SUBJECT: WATTS BAR UNIT 1 - SEISMIC MODELING AUDIT (TAC M90549)

OFFICE OF NUCLEAR REACTOR REGULATION  
SUMMARY OF SEISMIC MODELING AUDIT AT WATTS BAR UNIT 1

JUNE 20, 1995

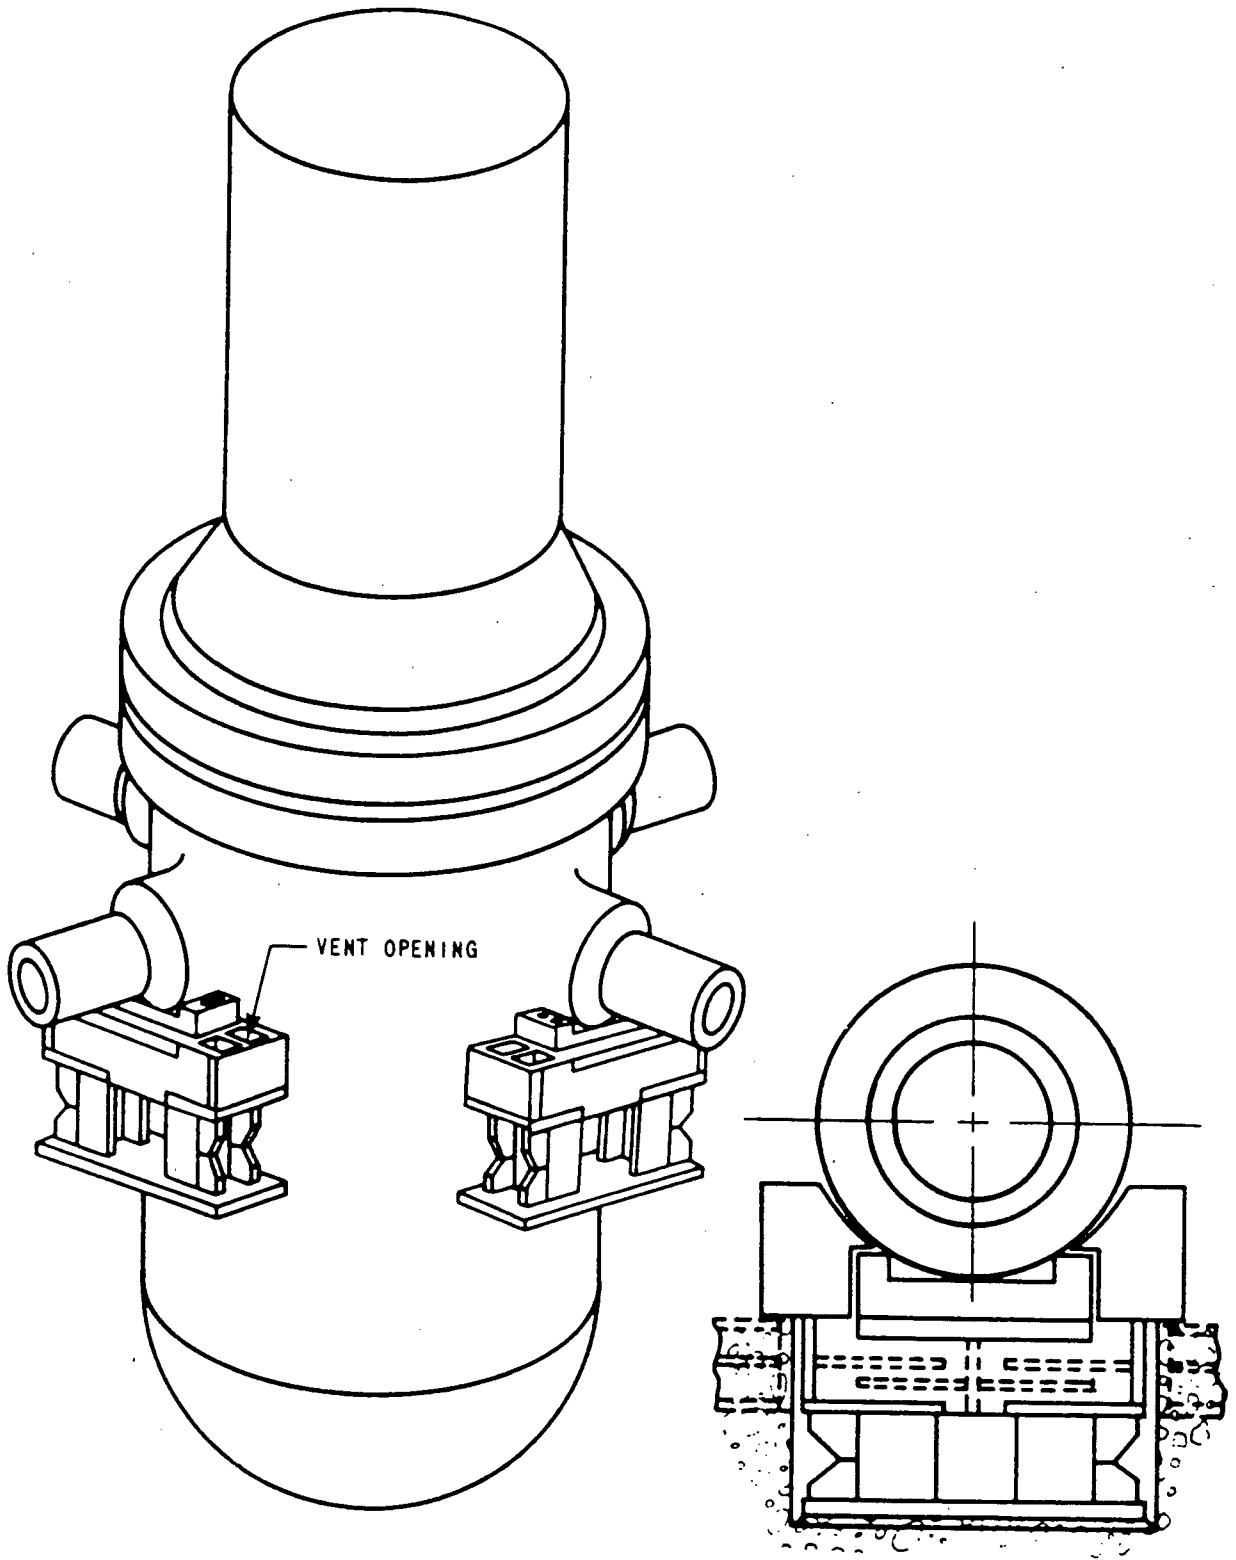
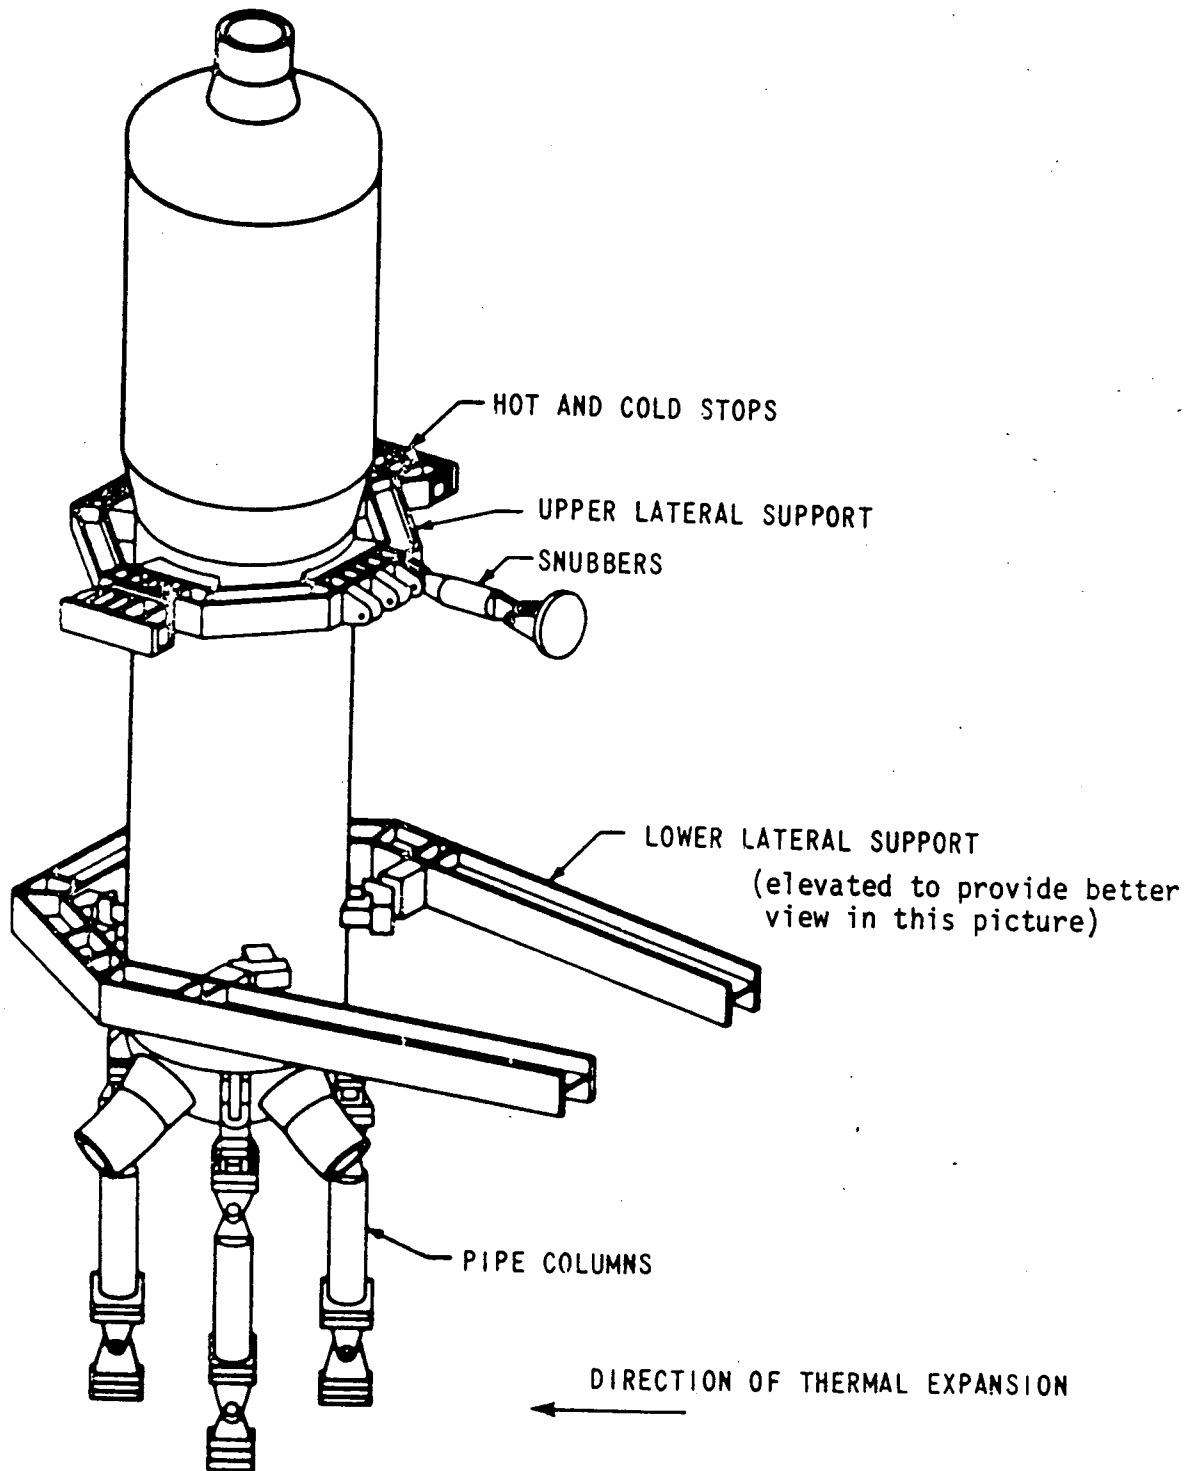
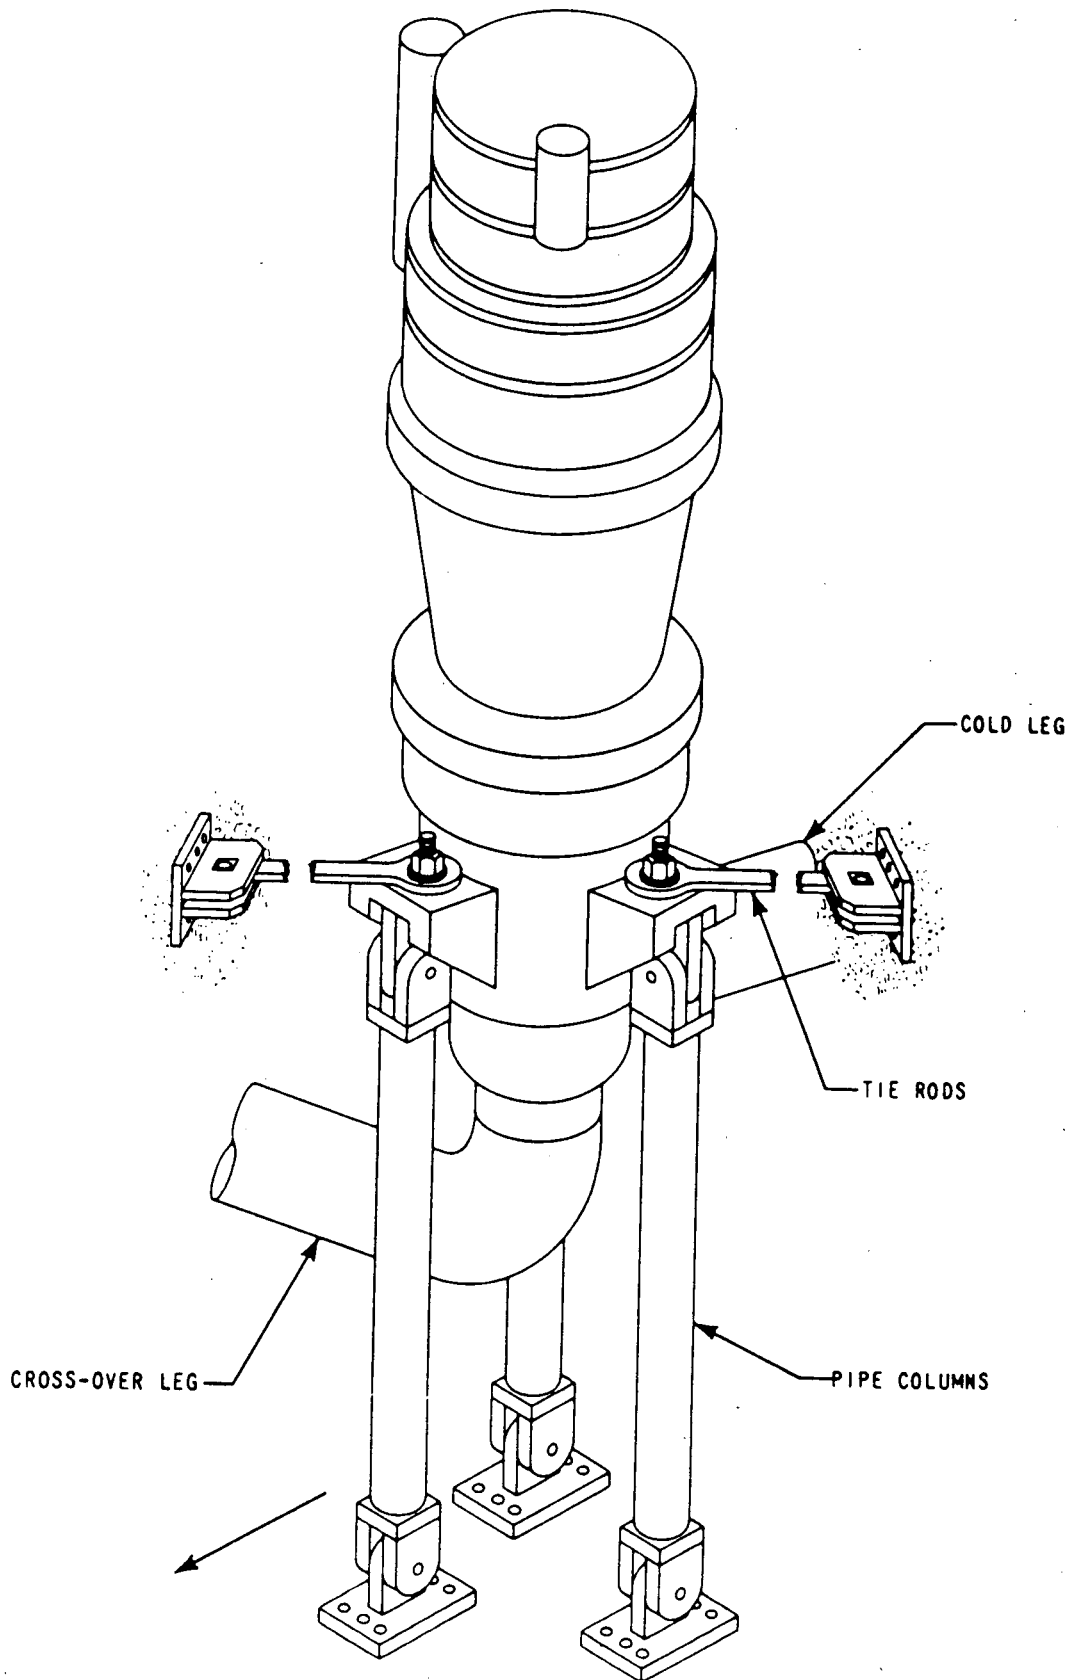
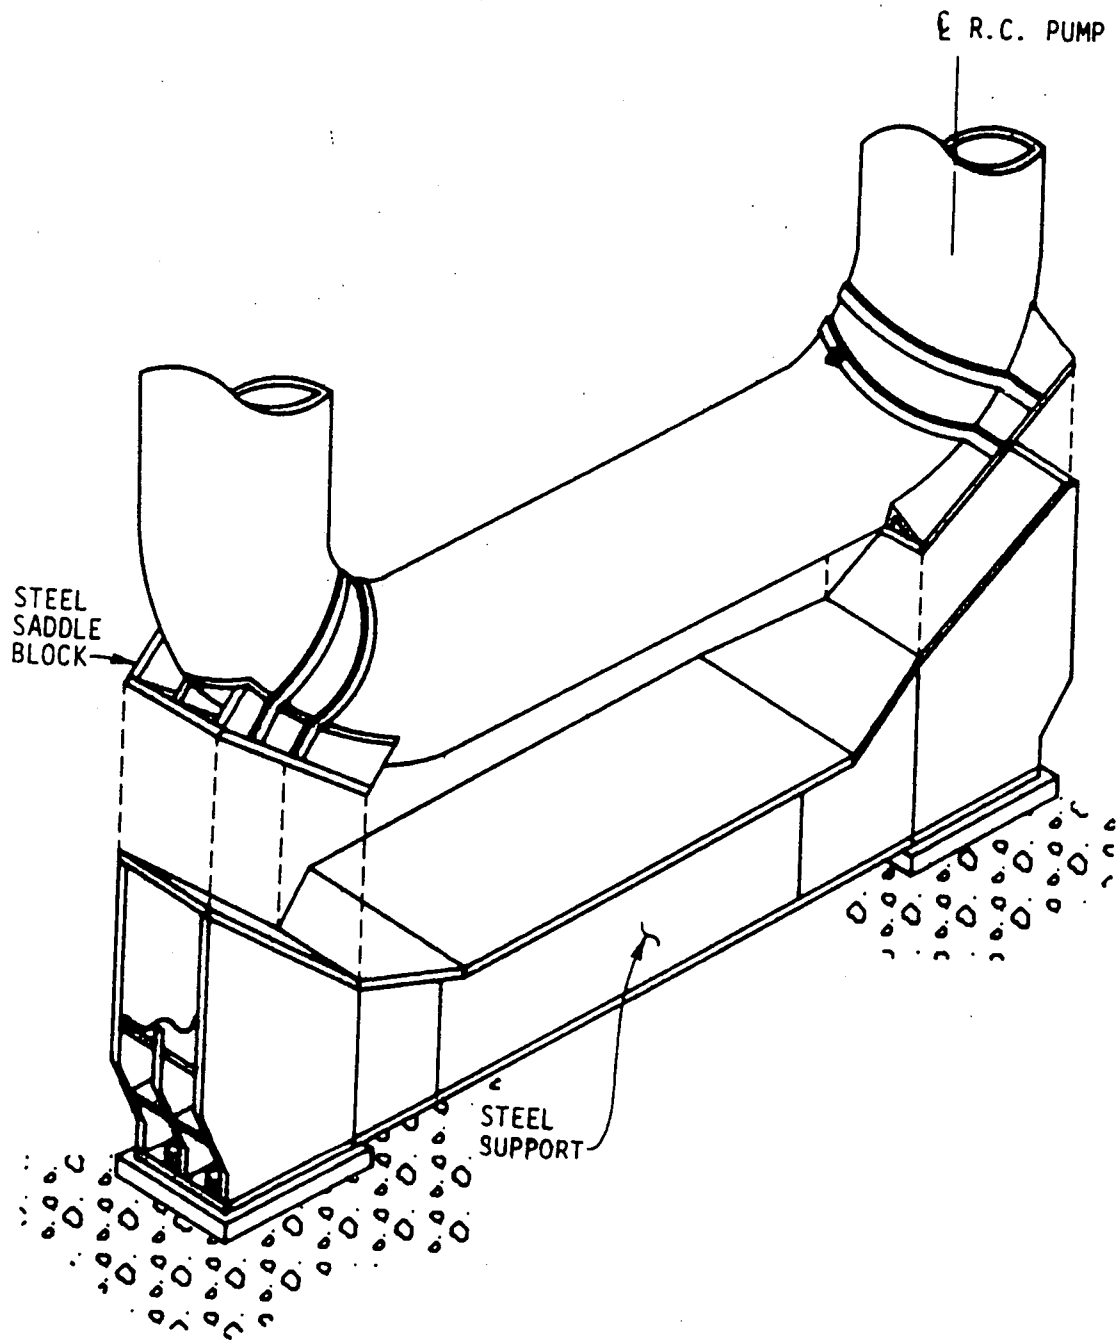
During the audit, TVA and Westinghouse presented the detailed construction configuration and modeling methodology for the NSSS supports. The NSSS components included in the coupled model for the ICS consist of the reactor pressure vessel (RPV), four loops of the primary reactor coolant loop (RCL) piping (hot legs, cold legs, and cross-over legs), the steam generator (SG), and the reactor coolant pump (RCP) associated with each loop. The NSSS models for four loops consist of masses and mass moments of inertia lumped at the nodal points of RPV, RCL piping, SG, and RCP, and interconnected with elastic elements. The stiffness properties of the elastic elements are represented by various 12 x 12 generalized stiffness matrices. For the purpose of linear response analyses, four linearized NSSS analyses, each with a unique set of linearized NSSS support stiffness, are used to bound the nonlinear support behavior under various dynamic loading conditions. For each NSSS analysis case, a specific set of NSSS supports with their specified orientation are activated for a particular loading condition and a set of linear support stiffnesses is provided to represent the active supports. The active supports for each of the four analysis cases are shown in Reference 3. A simplified diagram of the reactor coolant system is shown in Figure 1-2 of Attachment 3. Figures 5.5-6 through 5.5-10 of TVA's handout material show the support arrangement for RPV, SG, RCP, and crossover leg piping. An examination of the

active support conditions specified in Attachment 2, Tables A-1 through A-4 of Reference 4, show that the active support conditions for NSSS analysis cases 1 and 3 are complimentary to each other and are for resisting horizontal seismic loads in the plant north-south (NS) directions; the active support conditions for the NSSS analysis cases 5 and 6 are complimentary and are primarily for resisting loads in the plant east-west (EW) direction. For the vertical response analysis, the NSSS analysis cases 5 and 6 are used. It may be noted that the RPV supports are active for all conditions and hence, are appropriately modeled as linear elastic supports.

Westinghouse also presented the construction sketches (see handout material) and drawings for the RCL supports during the audit. Subsequent to the discussion, the staff performed a walkdown of the RCL supports and observed the configuration of the accessible SG, RCP, and crossover leg supports.

The staff concludes that it is common industry practice that pipe supports are constructed with gaps and that the supports are active only if the gaps close during the earthquake motion. The staff recognizes that linear elastic modeling of the pipe supports is a common industry practice as long as the overall analysis adequately models various support conditions. The staff further notes that linear elastic modeling of pipe supports which are active only in tension due to gaps is a common industry practice as long as the analysis adequately represents the actual support conditions. Based on the presentation of the various cases considered to model the RPV supports, SG upper and lower supports, crossover leg restraints on the SG and RCP sides, RCP lower supports, and RCP tie rods, the staff concludes that the NSSS-ICS coupled model appropriately represents the actual configuration and the enveloping of the response conservatively represents the seismic response of the NSSS-ICS structural system.
